118 MERCER

SDCI #3036517-LU (3036455-EG)

DESIGN REVIEW BOARD RECOMMENDATIONS

08/04/21

EDG RESPONSES - 2B SUN PORCH

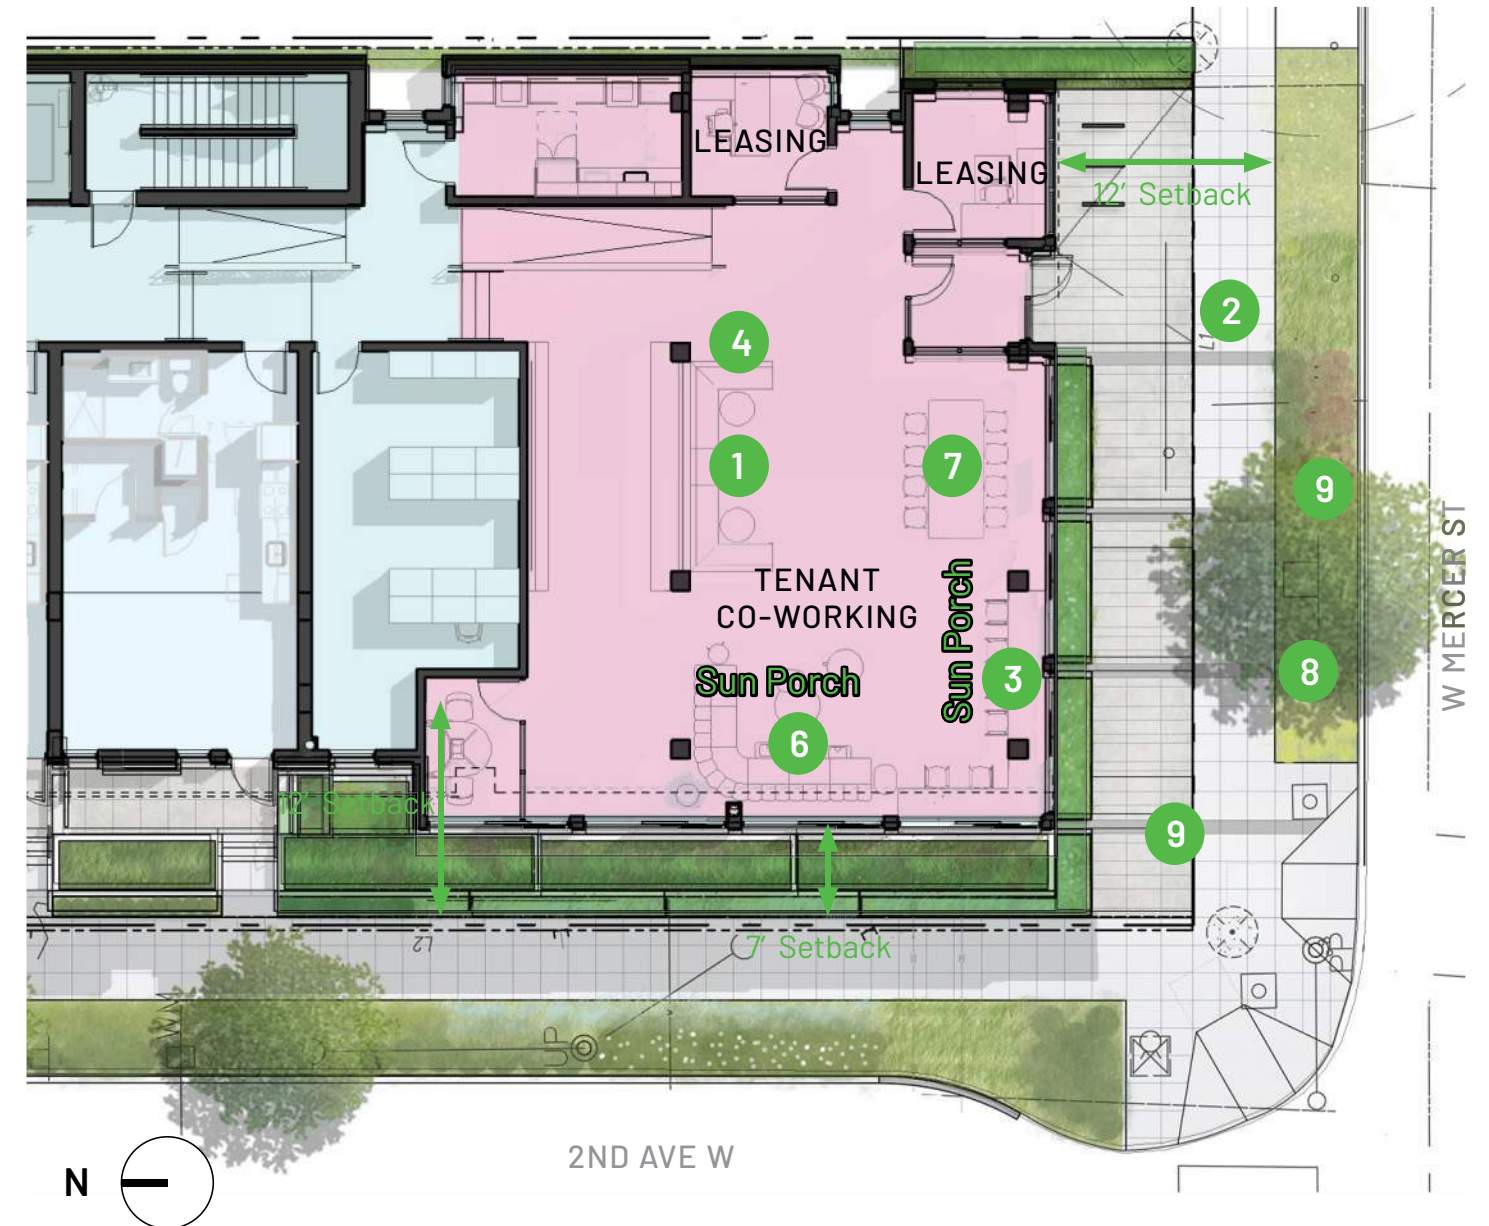
2b Study the interactions between the sun porch, public plaza and sidewalk. "Show it functions as a nuanced space."

The board supported the sun porch concept at the ground level of the building near the intersection instead of commercial space, and asked the applicant to study the interaction of the sun porch with the adjacent public space, with the intent to maximize street activation and connection between the indoor and outdoor spaces (PL1.3.C, DC1.A.1)

Acting as the "jewel box", this protruded form turns the corner as unifying element. The sun porch is a expressed bridging element at the plaza with articulated canopies and unique materiality. Building elements such as large operable windows and weather protection create a visual connection between the indoors and outdoors. A connection between the indoors and outdoors is empathized by the warm-colored louvers and wood interior ceiling. The urban sun porch provides a variety of seating arrangements such as bar seating and egg chairs to encourage the "third place" type of gatherings similar to a cafe. Diagrams on pages 46 -47 provide further analysis on the connection between the indoor and outdoor spaces.

EDG RESPONSES - 3A & 3B OUTDOOR STREET FRONTAGE

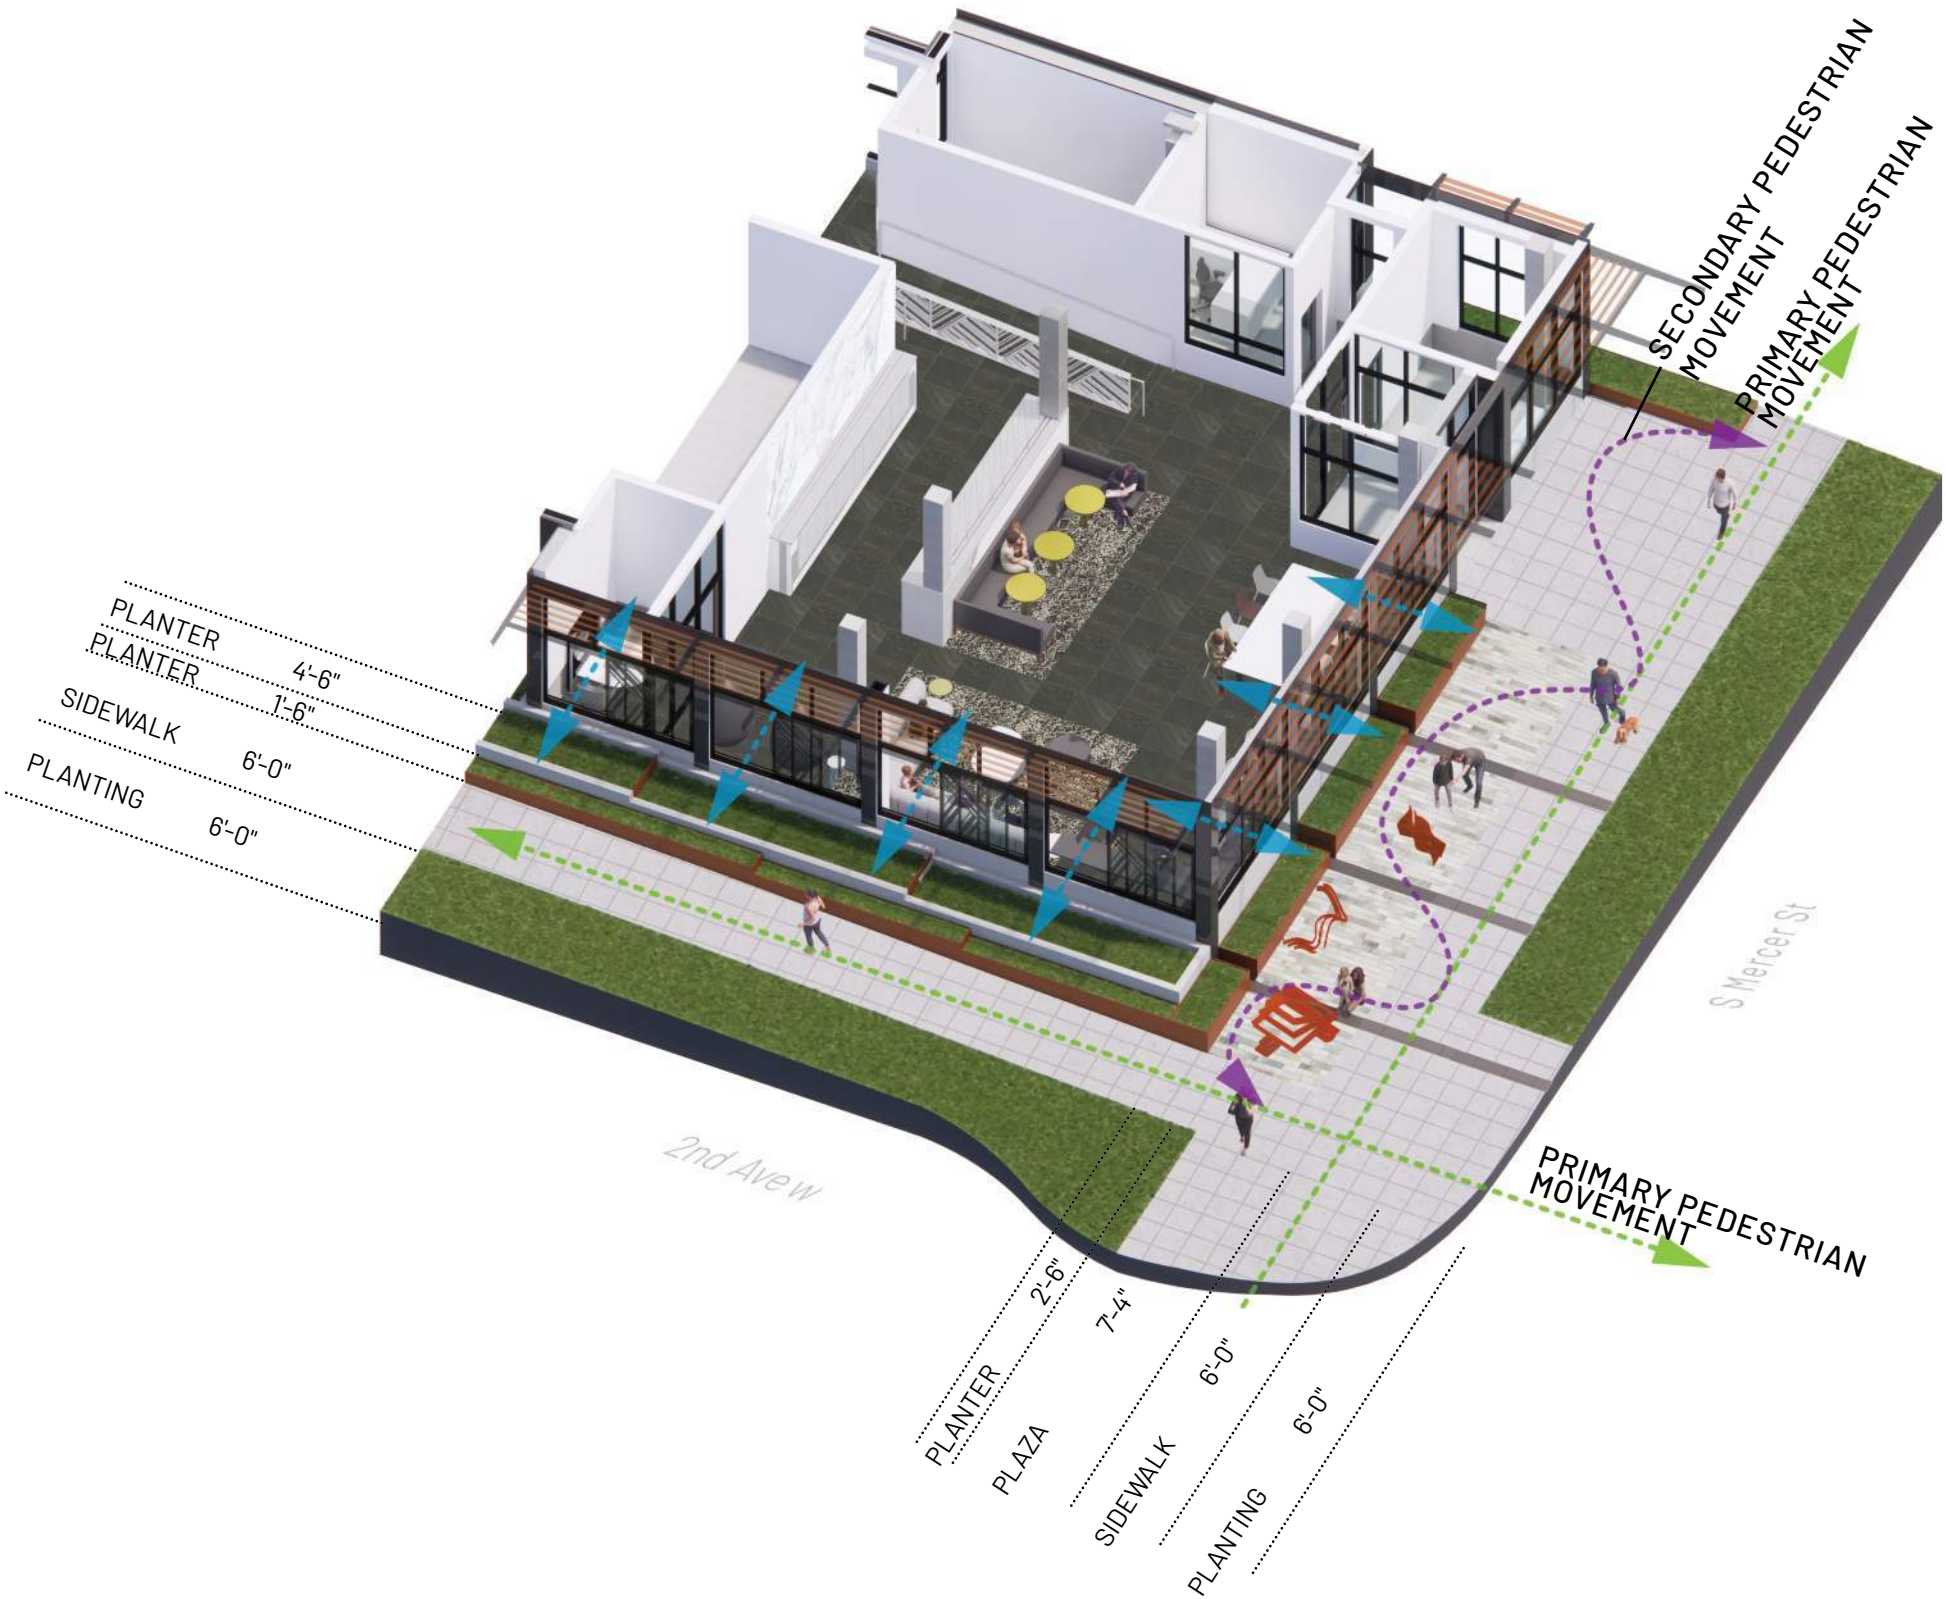
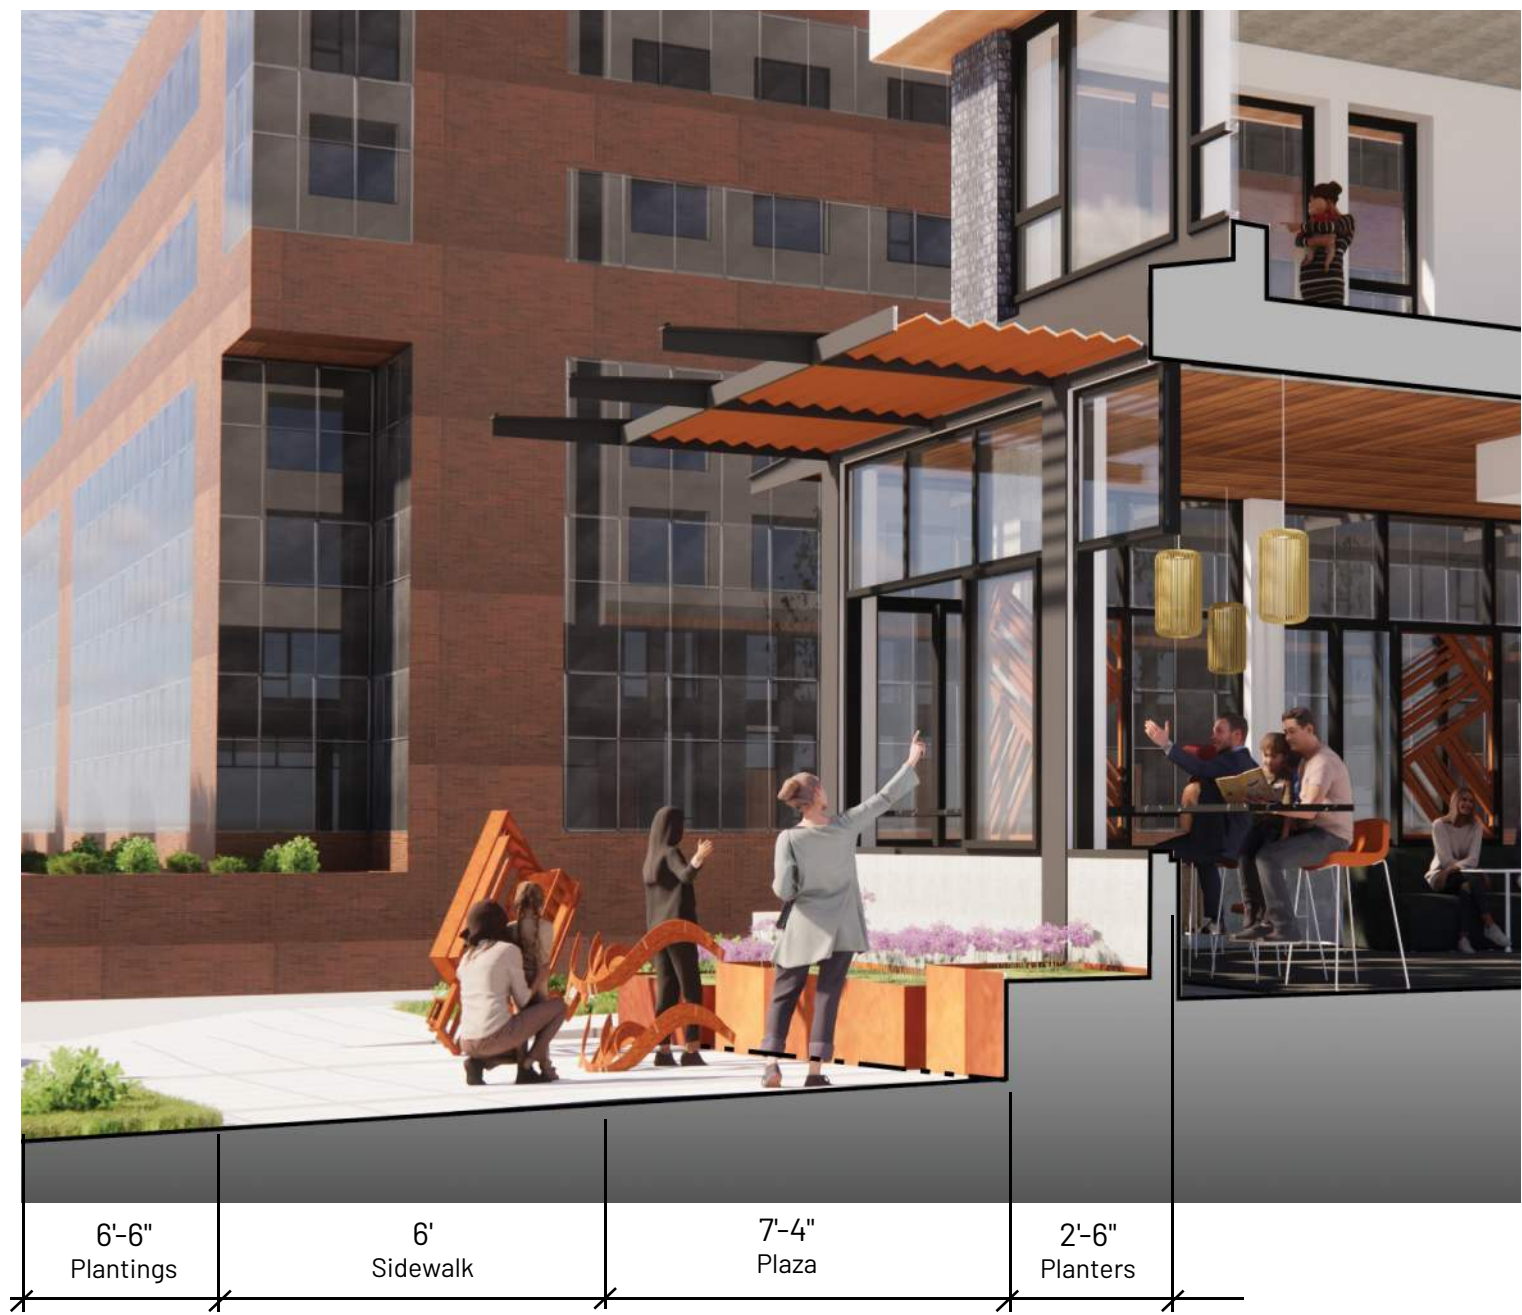
3a Study the interactions between the sun porch, public plaza and sidewalk. "Show it functions as a nuanced space."

The Board requested additional study of the design and programming of the plaza along W. Mercer Street to show that it will effectively function as a nuanced space that allows for congregation and effectively connects the sun porch to the sidewalk and, instead of serving only as an extension of the sidewalk. The additional study should include examination of pedestrian movements and design details like planter dimensions and plant sizes (Uptown CS2.3.C. Corner Sites-Special features, Uptown PL1.1.A. Connections, Uptown PL1.3.C. Pedestrian Uses, Uptown PL4.2. Planning Ahead for Bicyclists)

3b Study the interactions between the sun porch, public plaza and sidewalk. "Show it functions as a nuanced space."

Related to comment 2b, the Board expressed concern that a significant amount of the street frontage was designed as a landscape buffer separating the building from sidewalk and plaza areas. The Board requested additional study showing how the public would occupy or use this landscaped area and adjacent public space and how this landscape area will aid in connecting indoor and outdoor spaces surrounding the sun porch (Uptown CS2.3.C. Special features, Uptown PL1.1.A. Connections, Uptown PL1.3.C. Pedestrian Uses)

The design team has continued to study and refine the relationship between the sun porch and the public space with the goal of encouraging connection. A cohesive strategy of specialized paving, landscape features, building elements and artwork installations have been developed to connect the interior and exterior spaces.

Rather than treat the plaza as an extension of the sidewalk, the sidewalk is reclaimed as part of the plaza and sun porch element. Like a wide point in a river, the current of the pedestrian experience within the space is slowed down by providing a meandering path filled with points of visual interest (paving, landscape, art) as well as active connection to the sun porch interiors (operable windows).
